# **Great North Road Solar and Biodiversity Park**

Responses to Relevant Representations Report

Document Reference - EN010162/APP/8.8

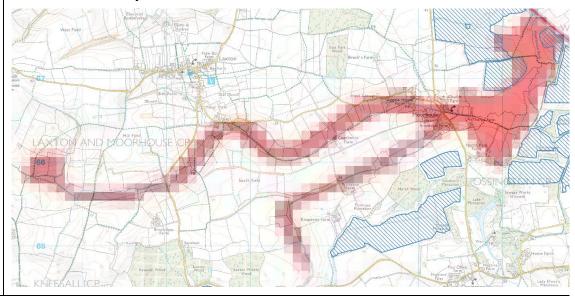
In its Land and Character Assessment (LCA), Newark and Sherwood District Council describe the Moorhouse Meadows landscape condition as good, but sensitivity as

The extent of the Moorhouse Meadowlands Policy Zone is identified on a small inset map at page 188 of the Newark and Sherwood Landscape Character Assessment SPD, and is shown below (in red), compared to the solar areas (blue hatch). As can be seen the proposed solar arrays largely avoid this area as part of the design approach as noted in Table 7.3 of ES Volume 2, Chapter 7: Landscape and Visual Impact Assessment (LVIA) [EN010162/APP/6.2.7] [APP-050]. Paragraph 8 describes this area in more detail of ES Volume 4, Appendix A7.5: Non-Significant Effects [EN010162/APP/6.4.7.2] [APP-212] and as shown below, just one arable field (of atypical character for this policy zone) to the east of Moorhouse Beck
